Engine: All Technical Service Bulletins

Technical Service Bulletin # **04-06-01-029E**

Subject: Unnecessary Flushing Services, Additive Recommendations and Proper Utilization of GM Simplified Maintenance Schedule to Enhance Customer Service Experience

Section 6E3 - Driveability and Emissions - Revised Chart C-4

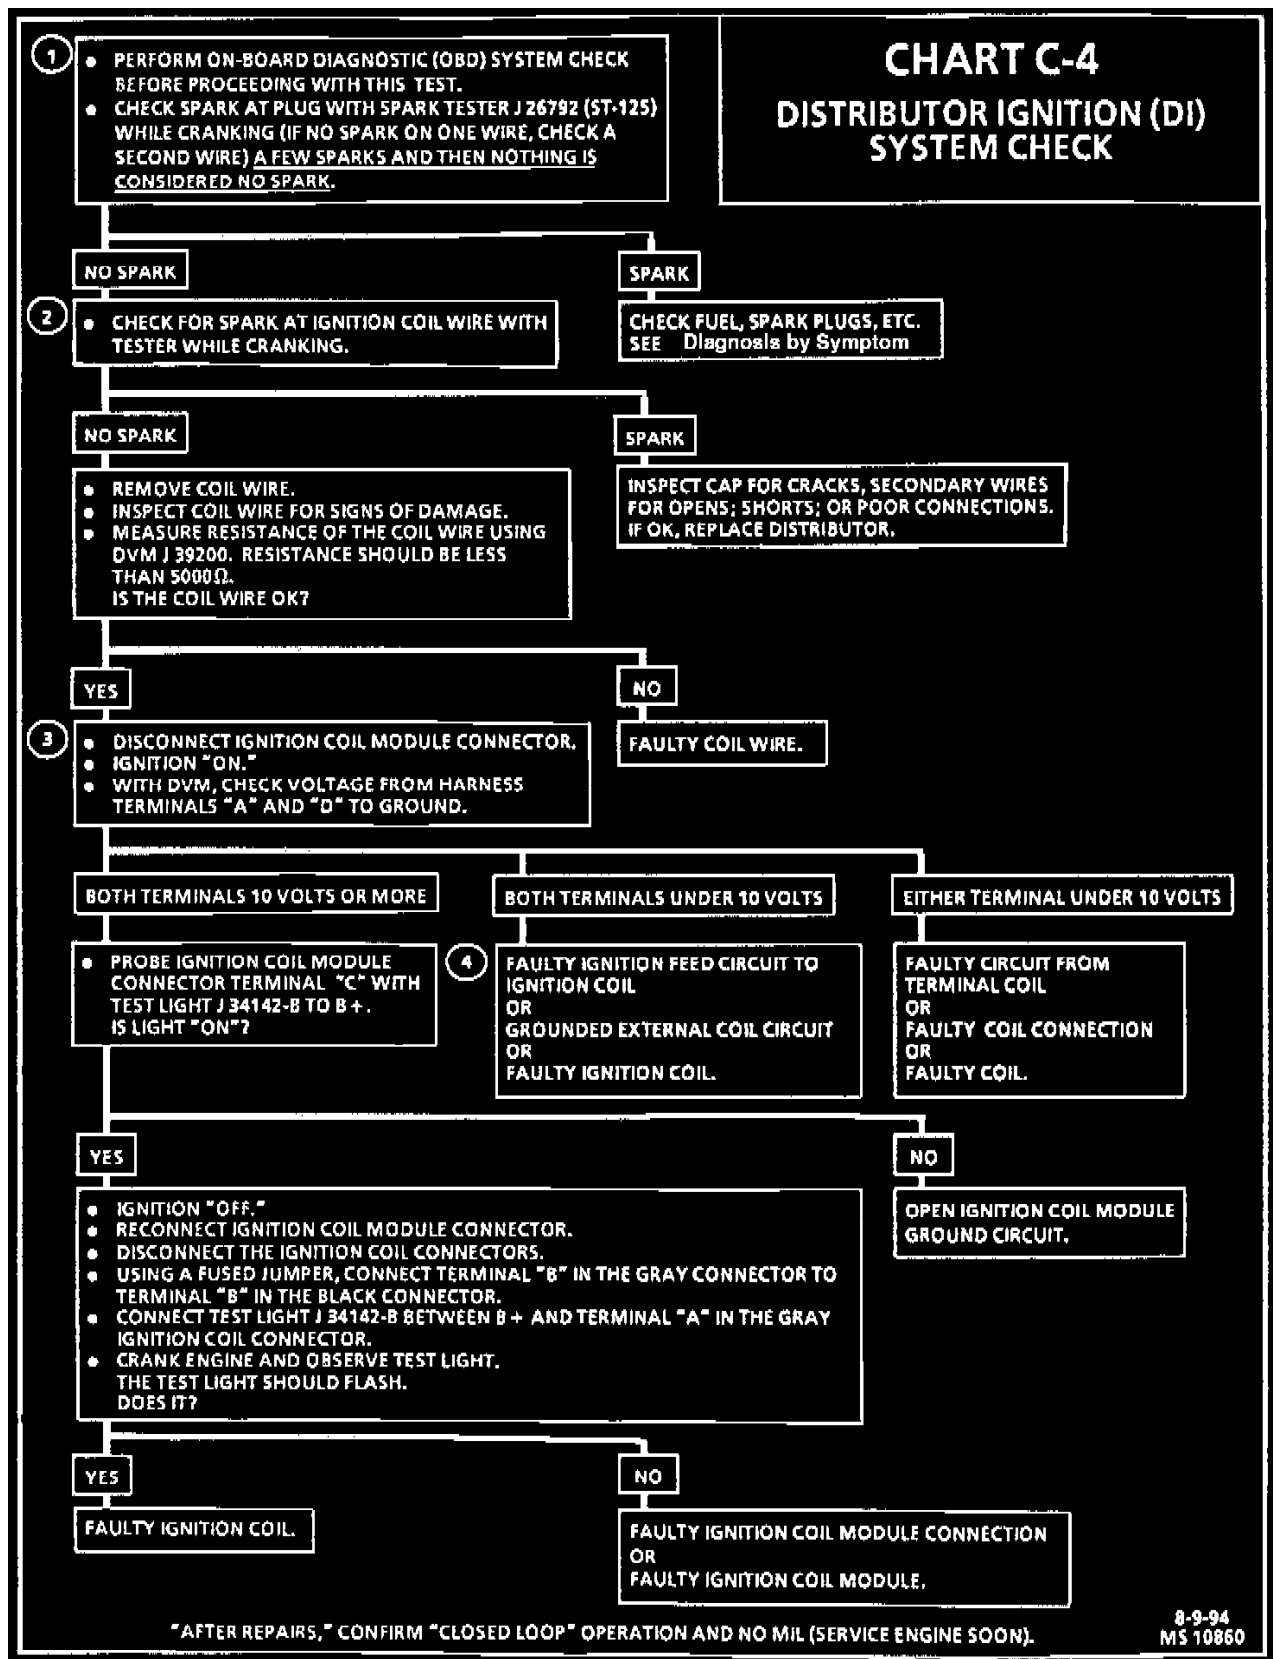
This bulletin updates the Distributor Ignition (DI) System Check in Section 6E3-Chart C-4. Use the chart and facing page provided in place of the existing Chart C-4 and facing page in the Service Manuals affected.
